MEETING MINUTES

RE: Taxiway and Apron Network
Technical Advisory Committee Meeting #1

Date of Meeting: December 3, 2019

- B. Don mentioned that we don't want to lose the capability to serve the existing aircraft as reconstruction projects occur.
- III. Stakeholder Feedback - Open conversation – The attached figure depicts the feedback given by stakeholders regarding the taxiway and apron system. See **Figure A**.

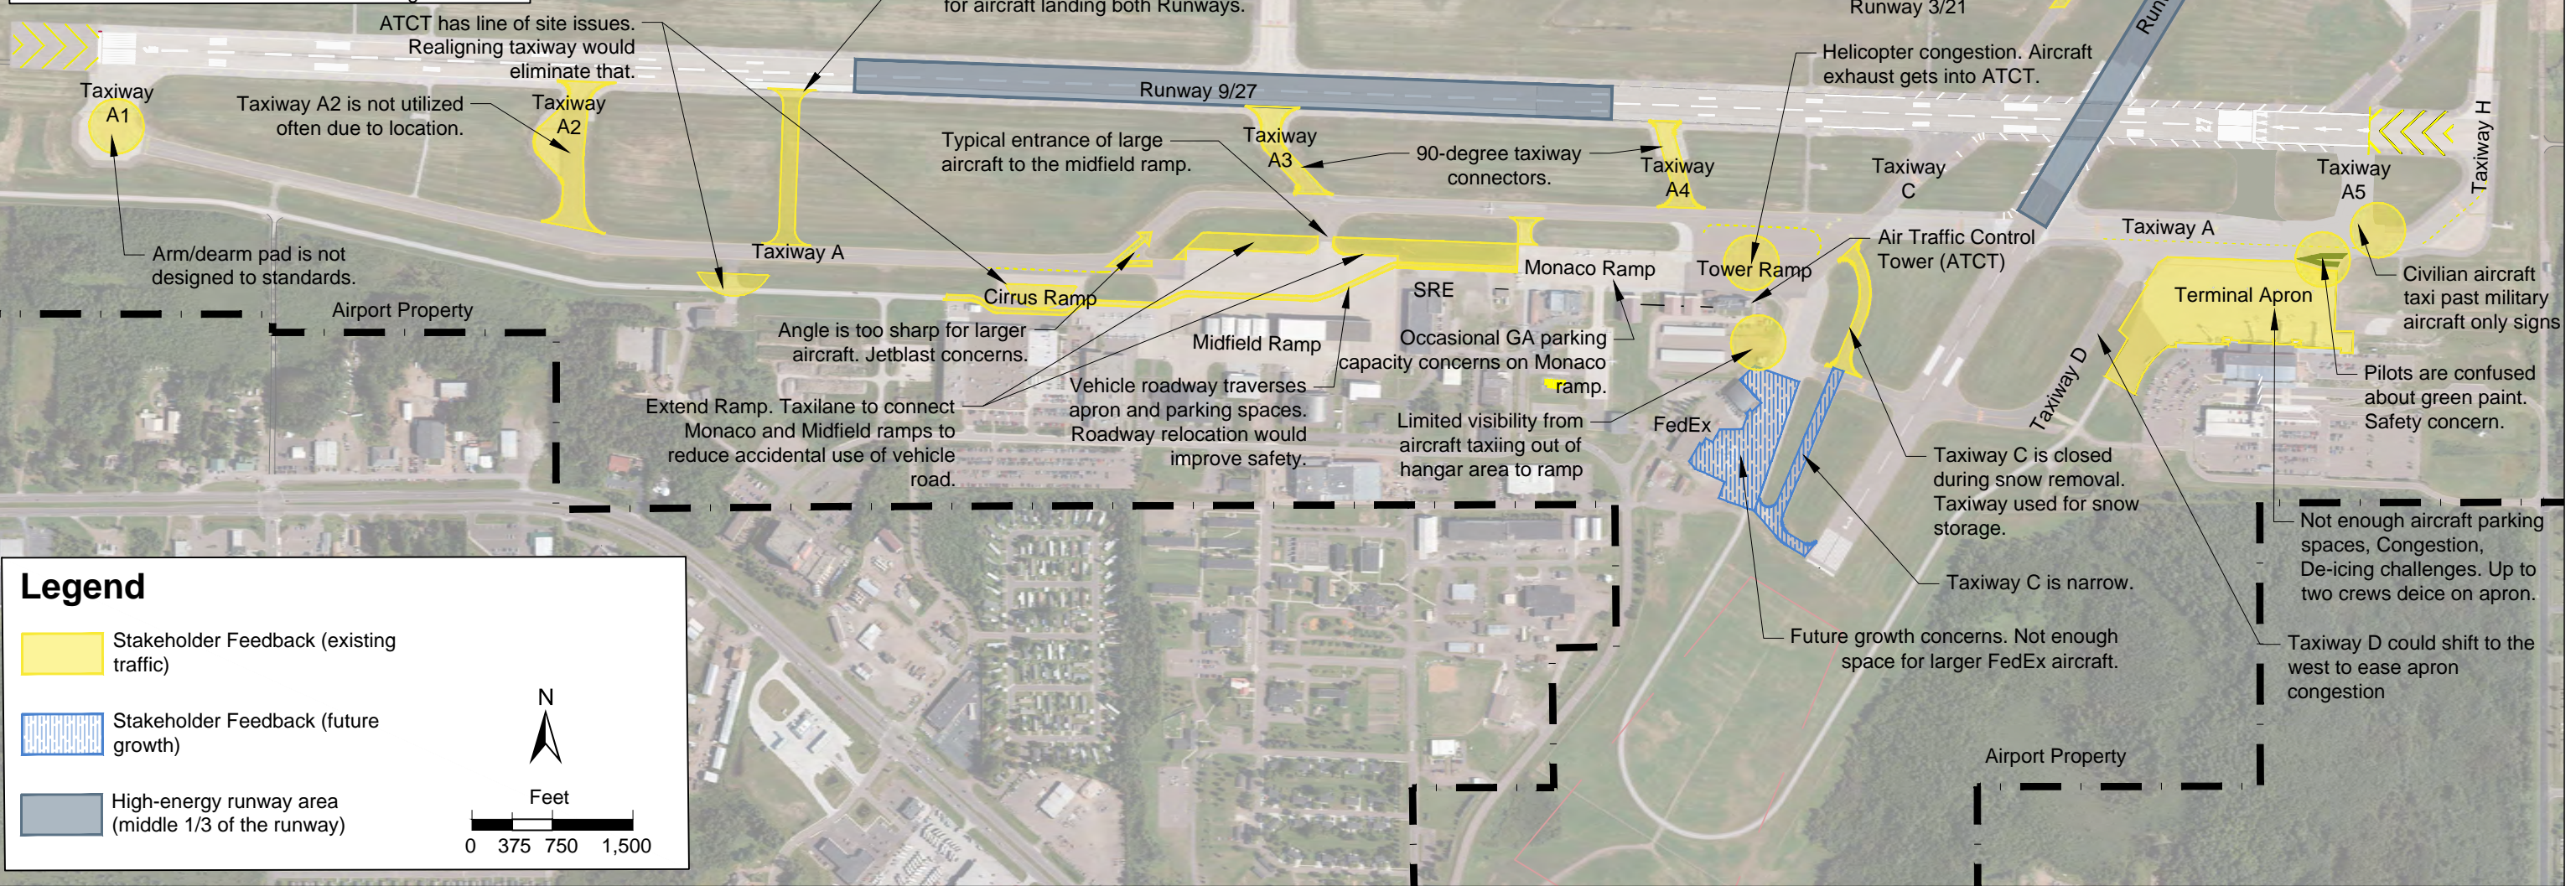
Future growth concerns. Taxiway B should connect to Taxiway C. Reduce runway crossings
ATCT stated they would not utilize this route for aircraft accessing Runway 21 unless from AAR or NBDA.

Large aircraft accessing Guard Ramp have difficulties making turn. Pavement is not suitable for heavier aircraft.

Taxiway F grade does not allow fighter jets to use.

Additional taxiway between A3 and A2 would increase usability for aircraft landing both Runways.

Aircraft hold location due to proximity of Taxiway C to Runway 3/21

Helicopter congestion. Aircraft exhaust gets into ATCT.

ATCT has line of site issues. Realigning taxiway would eliminate that.

Taxiway A2 is not utilized often due to location.

90-degree taxiway connectors.

Arm/dearm pad is not designed to standards.

Angle is too sharp for larger aircraft. Jetblast concerns.

Vehicle roadway traverses apron and parking spaces. Roadway relocation would improve safety.

Occasional GA parking capacity concerns on Monaco ramp.

Limited visibility from aircraft taxiing out of hangar area to ramp

Extend Ramp. Taxilane to connect Monaco and Midfield ramps to reduce accidental use of vehicle road.

Civilian aircraft taxi past military aircraft only signs

Pilots are confused about green paint. Safety concern.

Not enough aircraft parking spaces, Congestion, De-icing challenges. Up to two crews deice on apron.

Taxiway D could shift to the west to ease apron congestion

Taxiway C is closed during snow removal. Taxiway used for snow storage.

Taxiway C is narrow.

Future growth concerns. Not enough space for larger FedEx aircraft.
